Docket Item #2 & #3
BAR CASE # 2016-00342 & 00343

BAR Meeting
November 16, 2016

ISSUE: Partial demolition and Addition/Alterations

LOCATION: 317 South Lee Street

SOUTH LEE STREET
Existing Site Plan
1" = 20'-0"

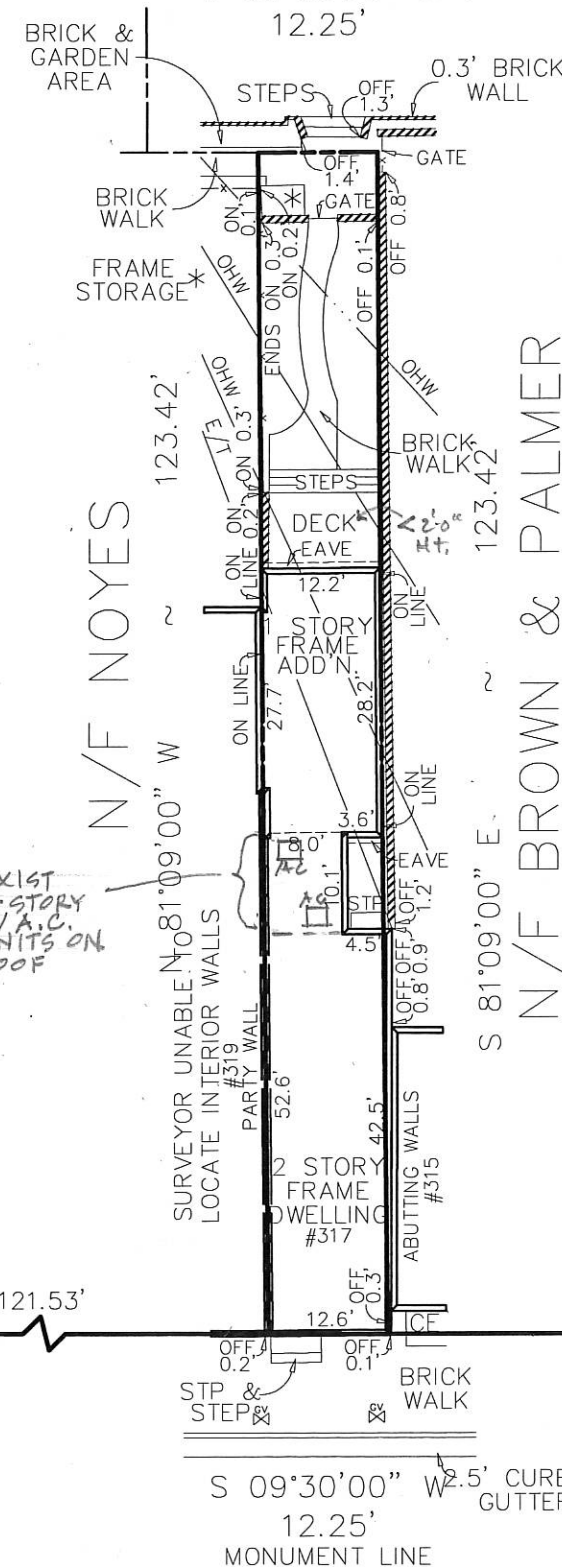
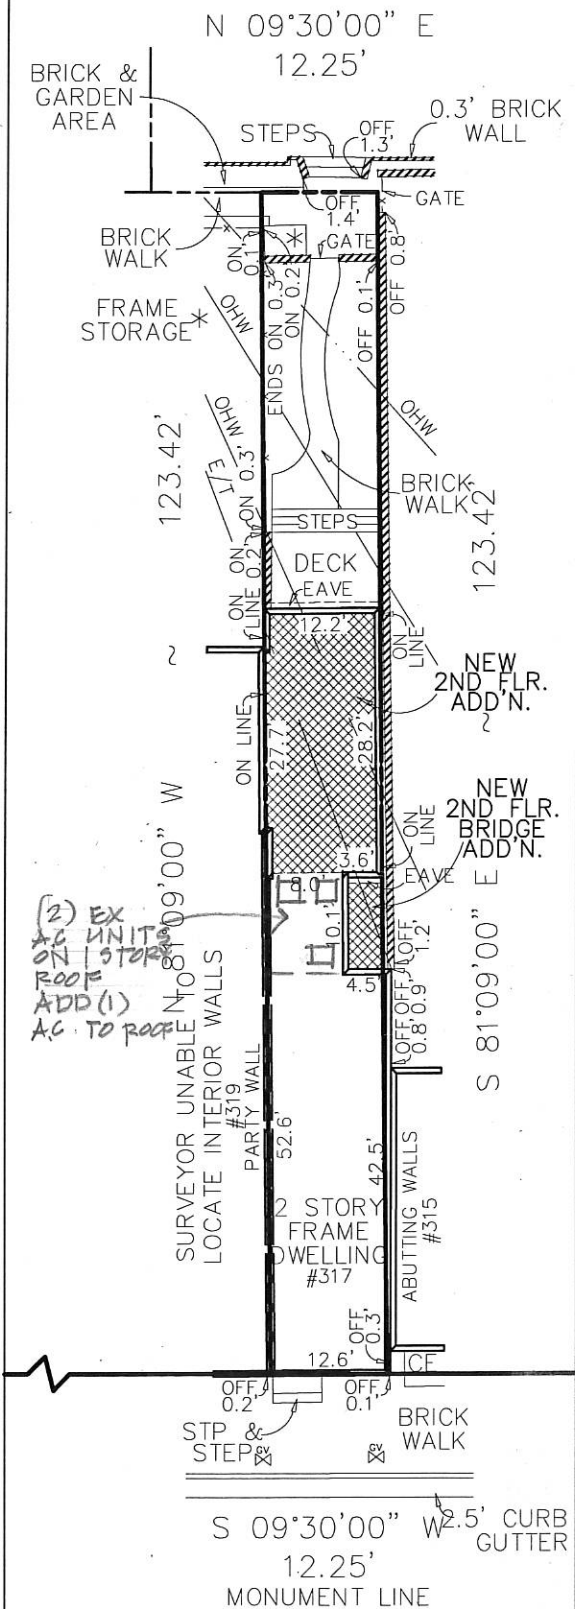
At the November 6, 2016 hearing, there was confusion about the stated height of the existing deck in the rear yard and whether it could be counted as open space, as the proposed “bridge” over the interior courtyard open space would not be permitted if the lot was deficient in standard open space. Staff visited the site on November 11, 2016 and confirmed that the deck is less than two feet above the grade of this parcel and, therefore, complies with the minimum open space requirements of the zoning ordinance. The proposed second floor bridge may therefore be constructed above the non-contributing (less than 8’ x 8’) open space area.

- C-1 Applicant must maintain at least 529 square feet of open space. A total of 530.67 square feet (43.32' by 12.25') in the rear yard is proposed.
- C-2 Proposed addition complies with zoning.
- F-2 Existing rear deck and stairs are less than 2' in height and can be included in the open space calculation.

EXIST'G/DEMO WEST ELEV/SECT.
@ COURTYARD
1/4" = 1'-0"

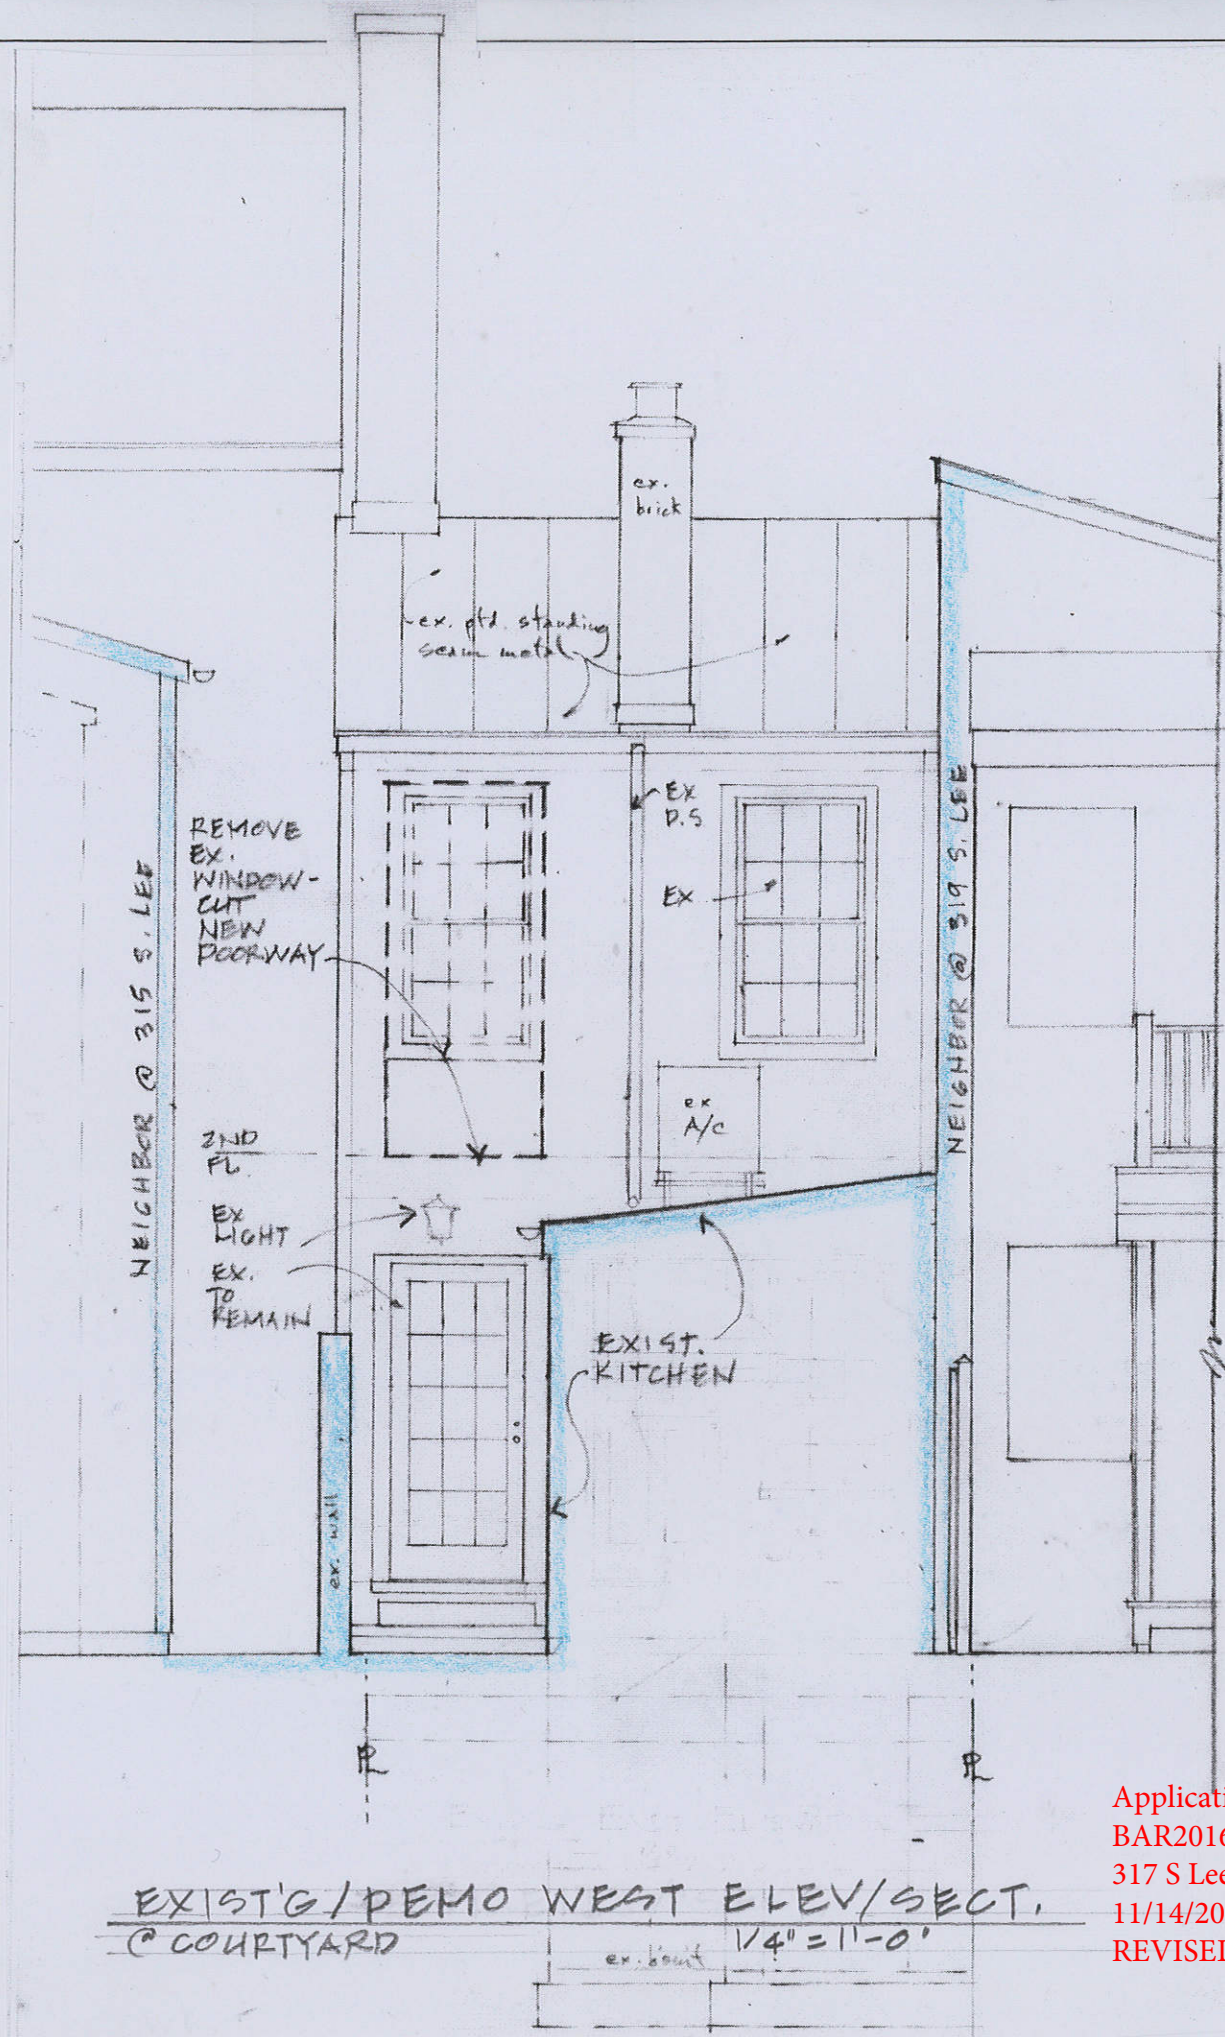
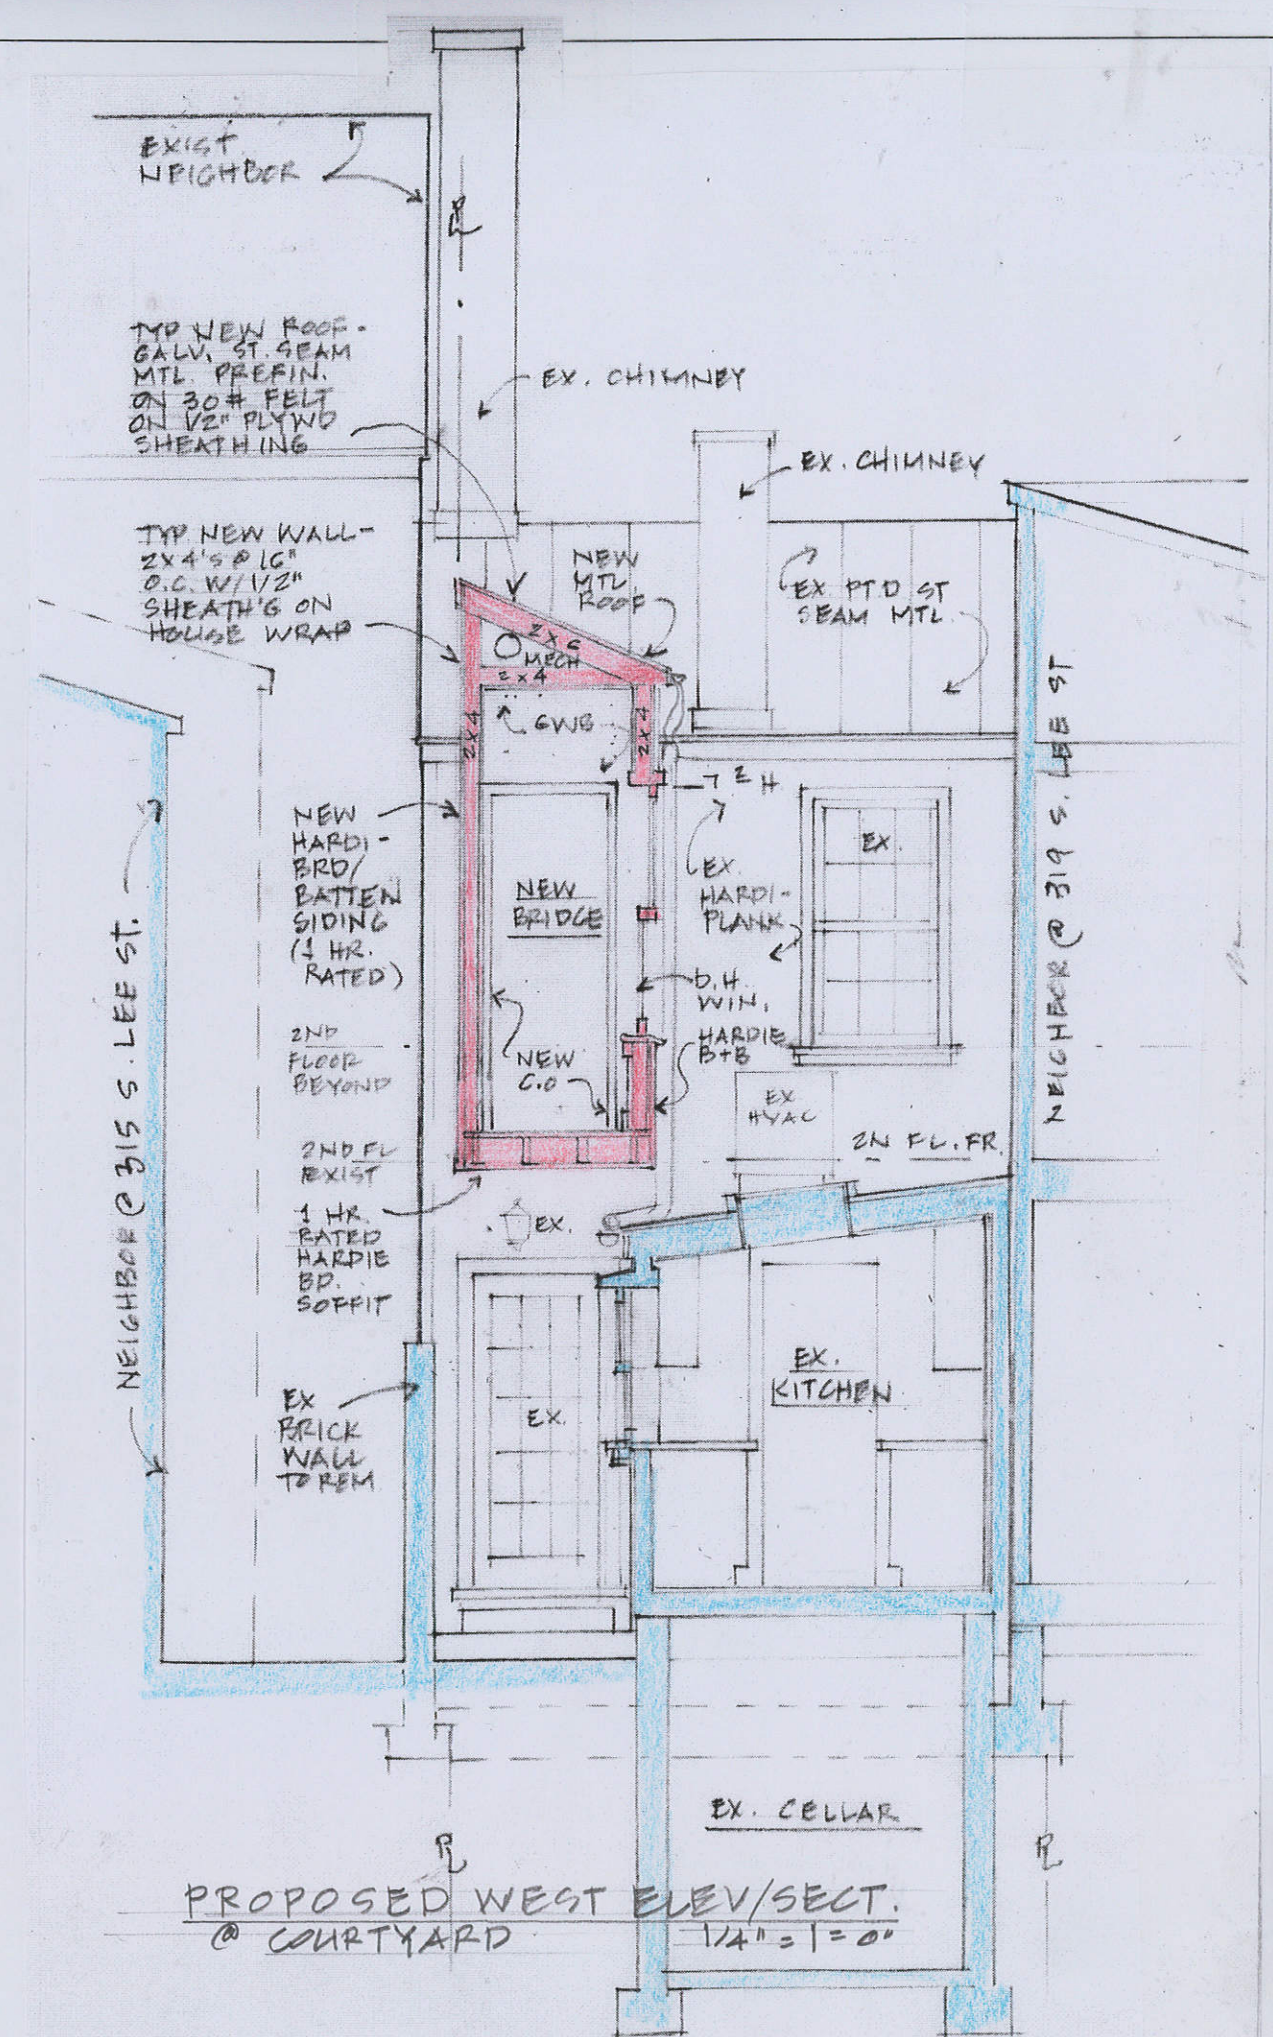
The applicant's drawings have been enlarged and reformatted for clarity, as requested by the BAR. As mentioned above, the applicant has also submitted revised building sections and elevations to depict the amended form of the roof over the proposed addition, lowering it on the west end so that it does not conflict with the neighbor's chimney. The east end of the addition still contains an attic to provide room for a ducted mini-split HVAC system.
